STATE OF HAWAII
DEPARTMENT OF TRANSPORTATION
HIGHWAYS DIVISION
WAIKAWA INTERCHANGE

CONTRACT CHANGE ORDER #8
TELEPHONE REVISIONS
ALONG ROAD "A"
F.A.I.P. No. I-HI-1(75):8
Date: 9/8/70

CONTRACT CHANGE ORDER #17
ELECTRICAL REVISIONS
ALONG ROAD "A"
F.A.I.P. No. I-HI-1(14):8
Date: March 1971

STATE OF HAWAII
DEPARTMENT OF TRANSPORTATION
HIGHWAYS DIVISION
CONTRACT CHANGE ORDERS
#8 & #17
F.A.I.P. No. I-HI-1(75):8
F.A.I.P. No. I-HI-1(14):8
SCALE: AS SHOWN

CONTRACT CHANGE ORDER #8
TELEPHONE REVISIONS
ALONG ROAD "A"
F.A.I.P. No. I-HI-1(75):8
Date: 9/8/70

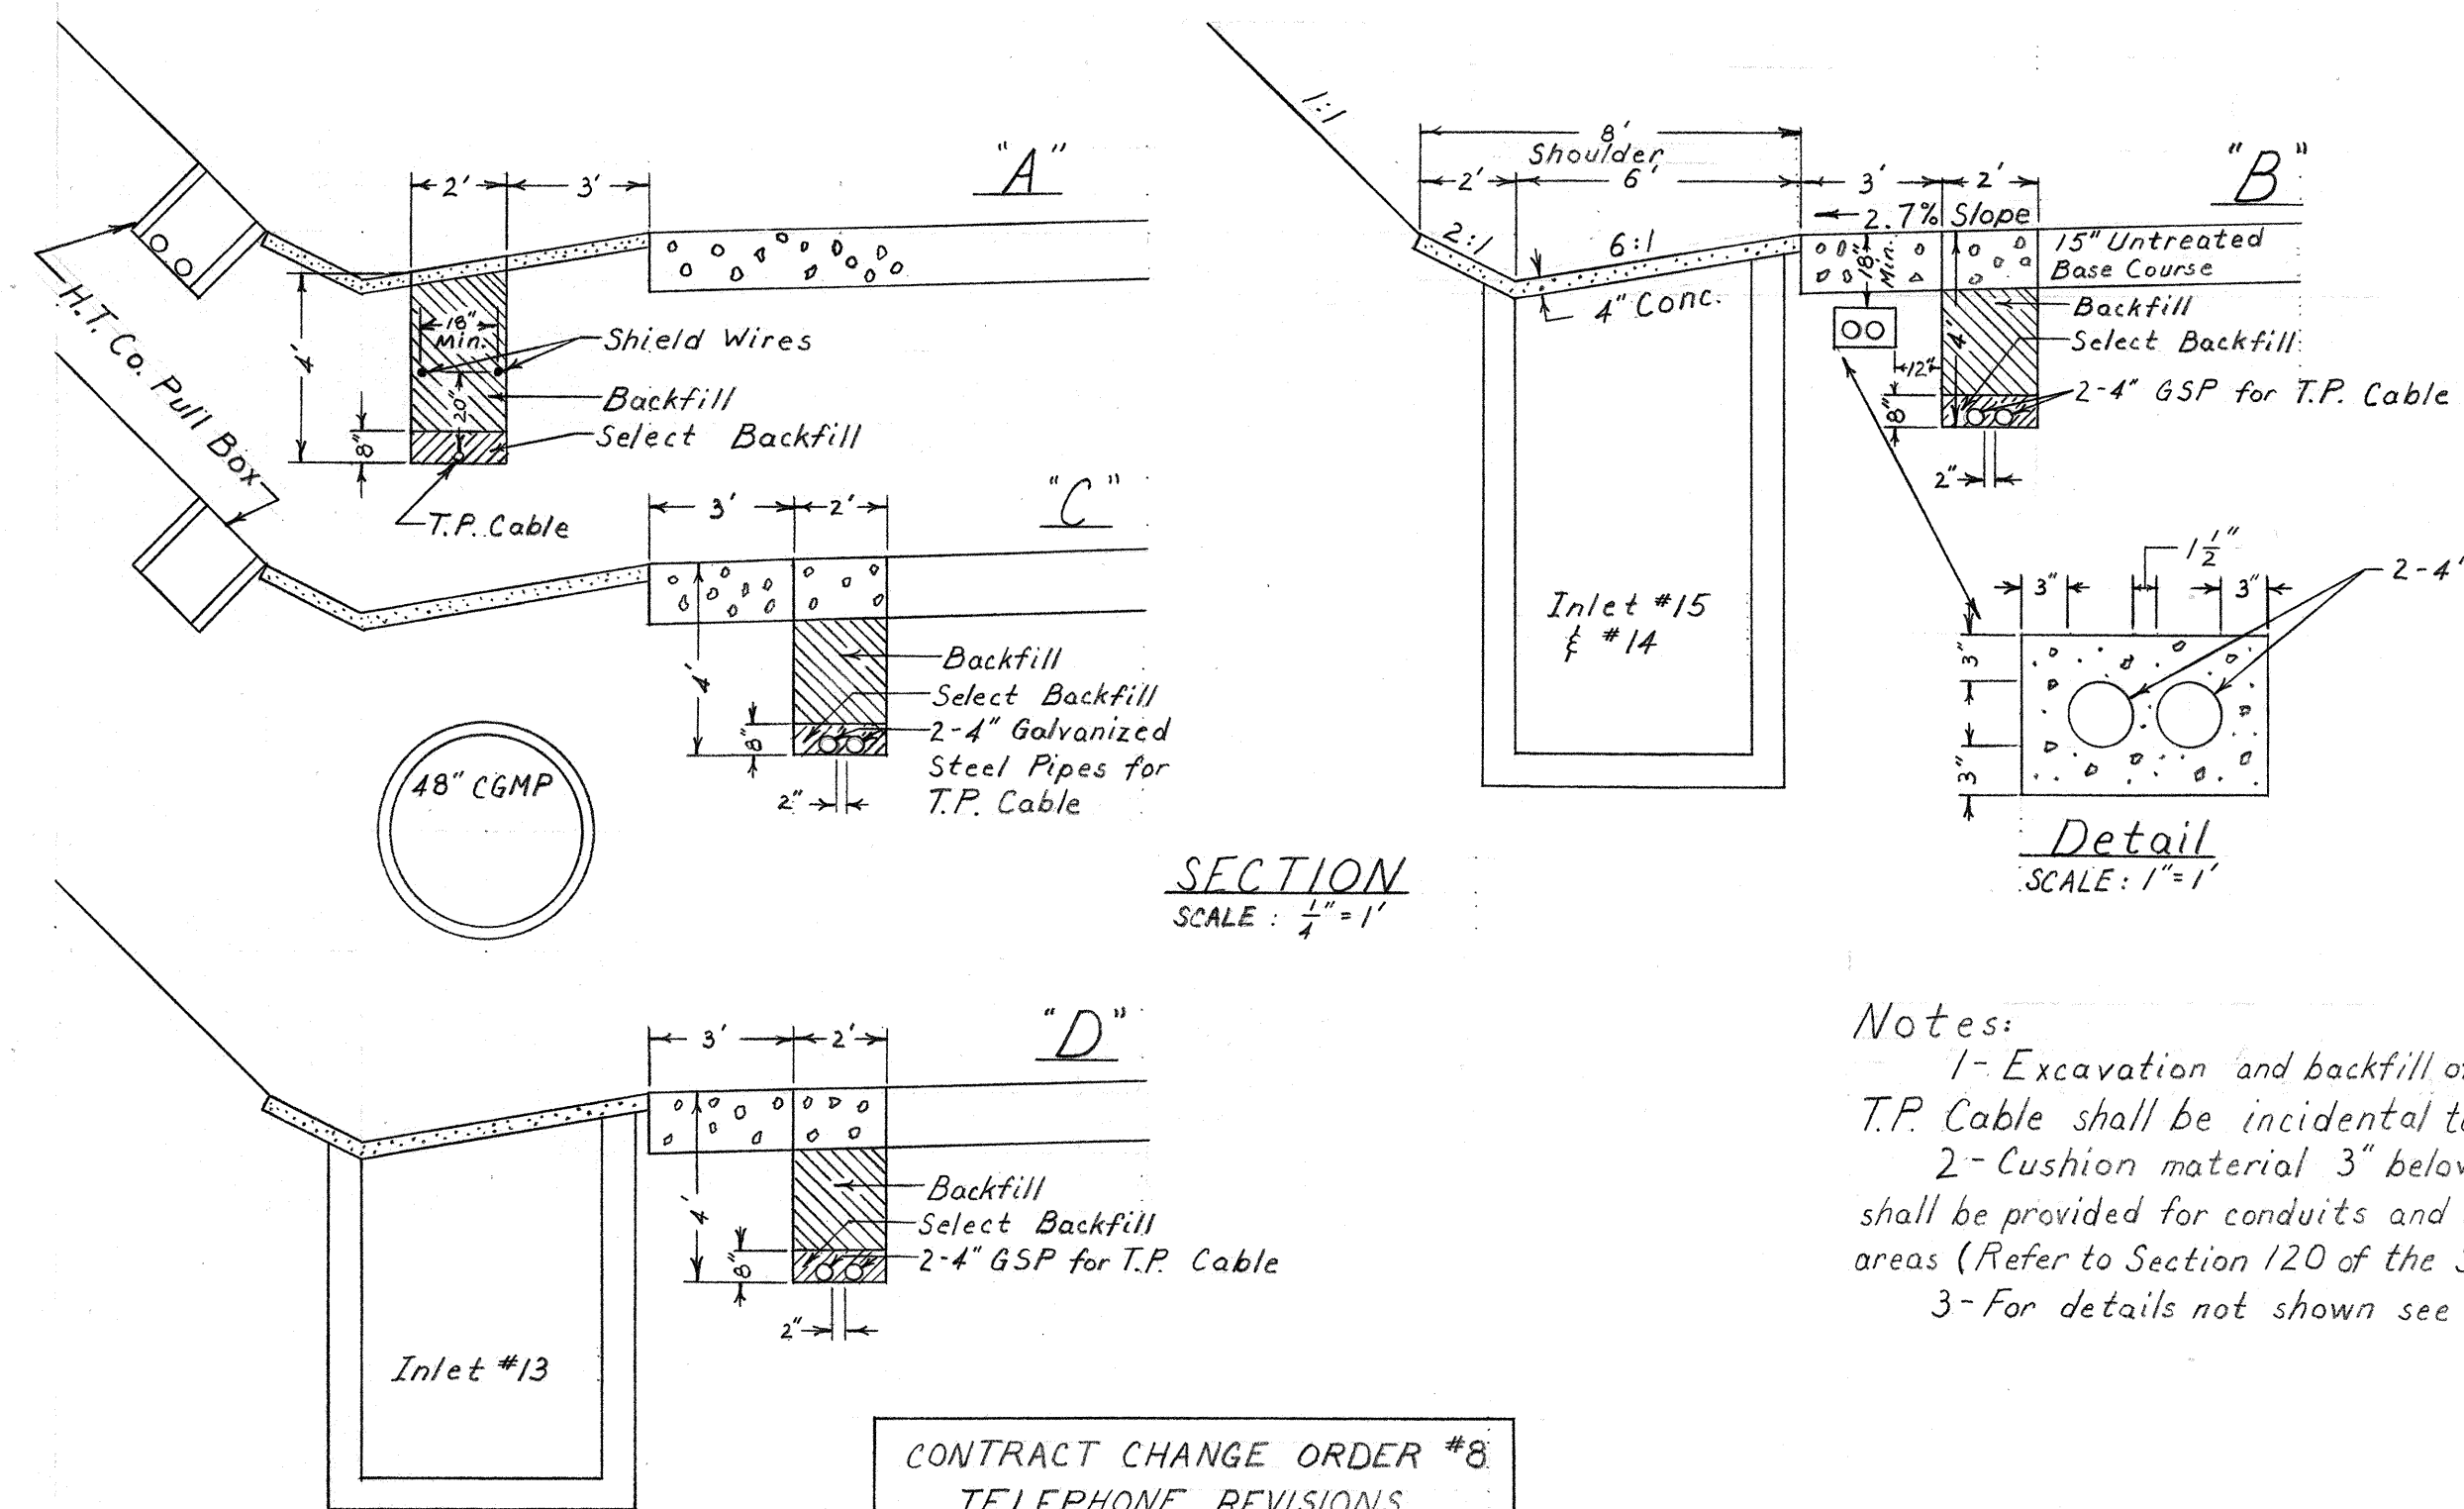
LEGEND
--- T.P. Cable
--- 2-4" Conduits
Encased in Concrete

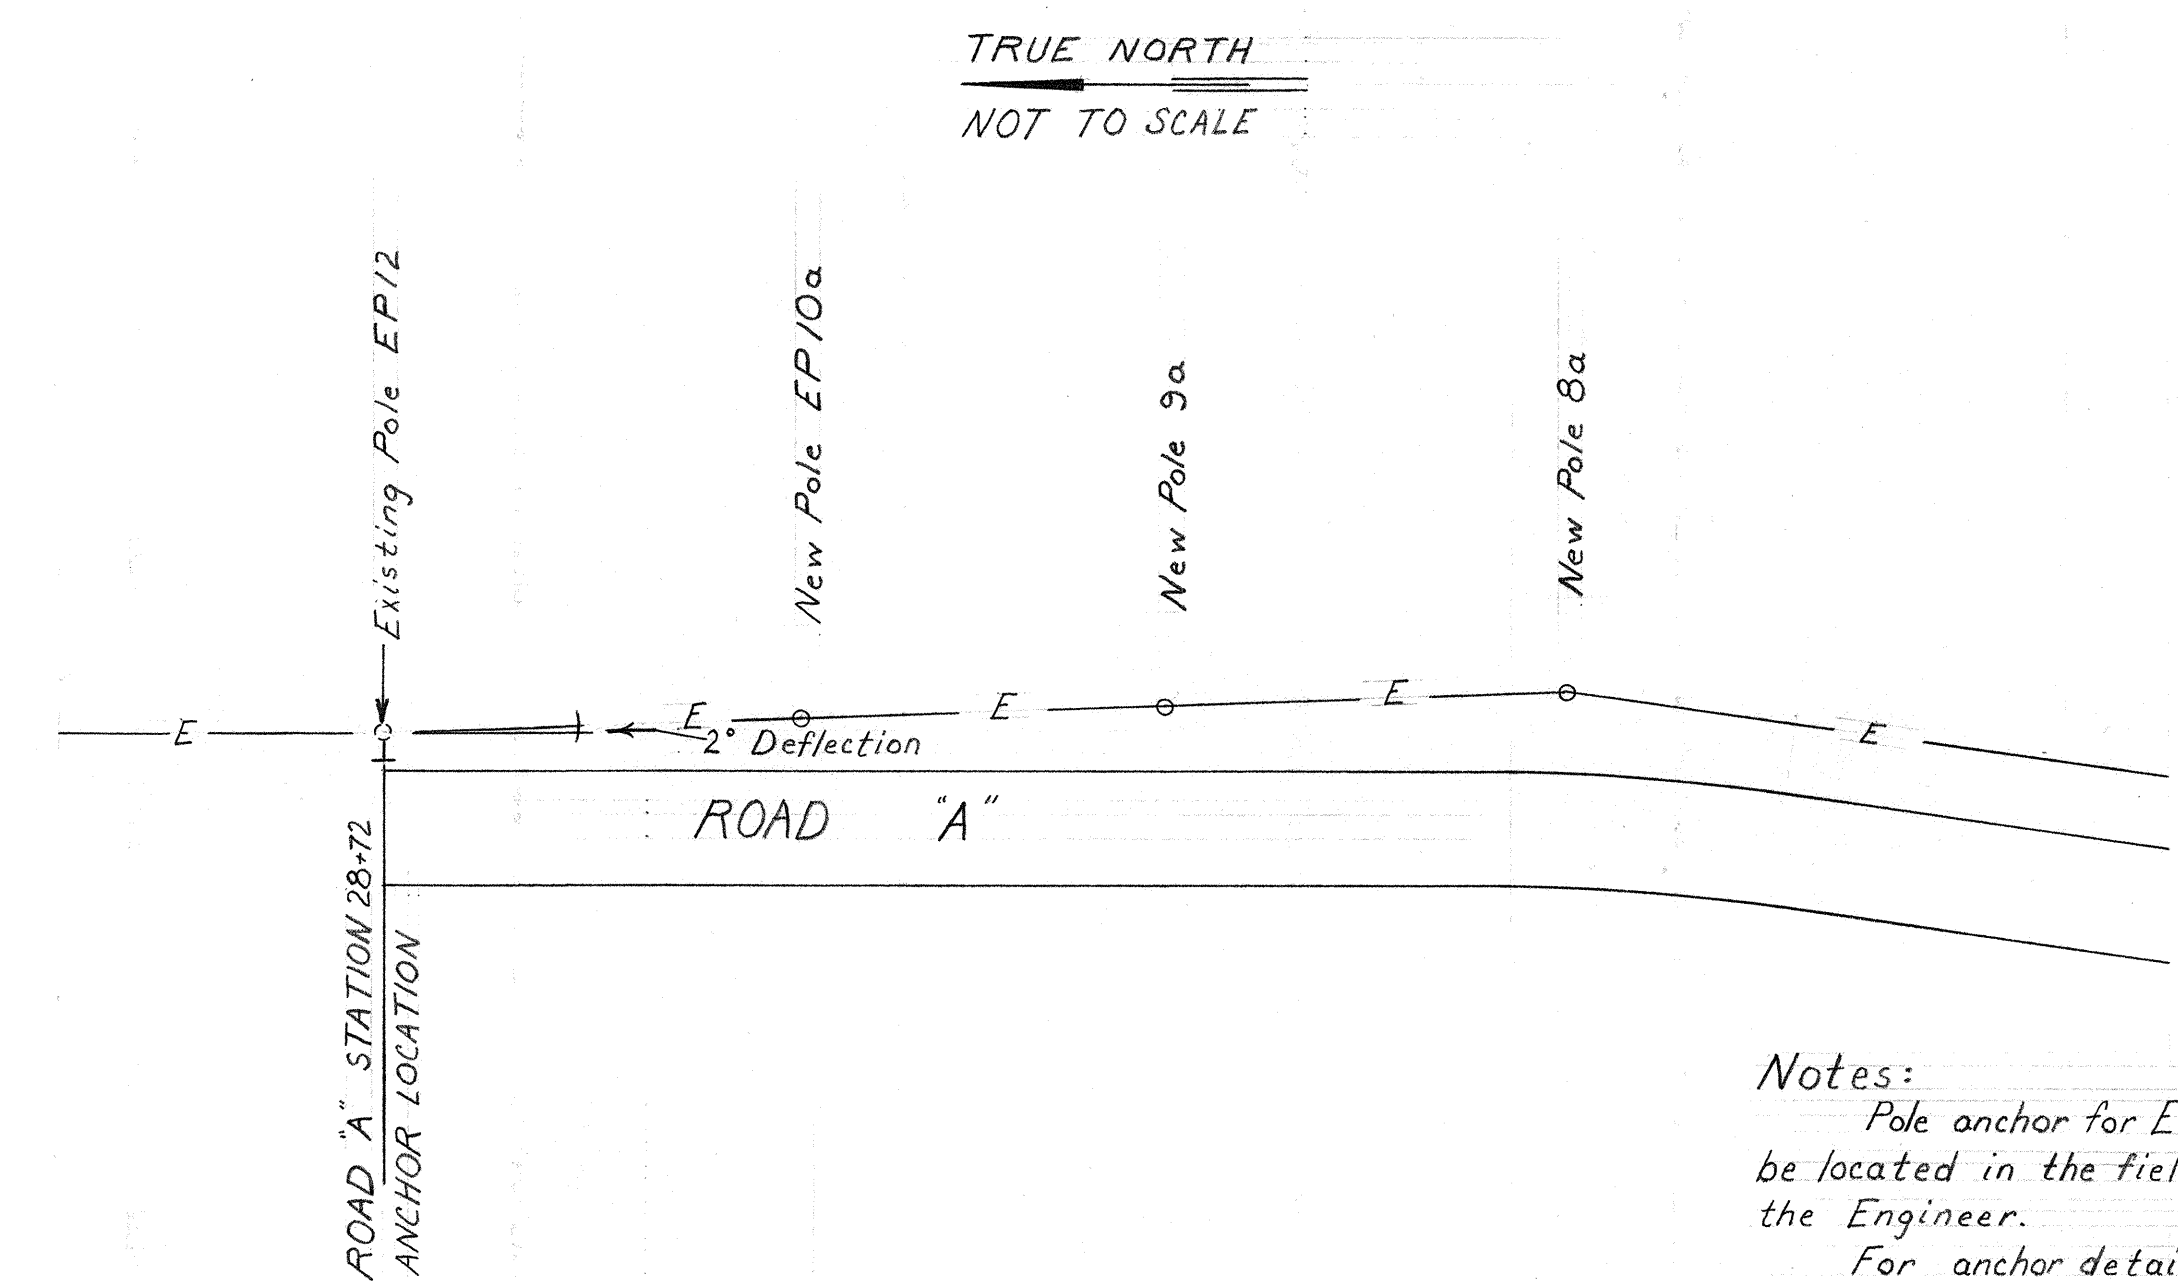
Notes:
1- Excavation and backfill of 2-4" GSP for T.P. Cable shall be incidental to Item No. 120. 3571.
2- Cushion material 3" below invert grade shall be provided for conduits and cables in rocky areas (Refer to Section 120 of the Special Provisions)
3- For details not shown see Contract Plans.

Notes:
Pole anchor for EP12 to be located in the field by the Engineer.
For anchor detail see Plan Sheet No. 55.
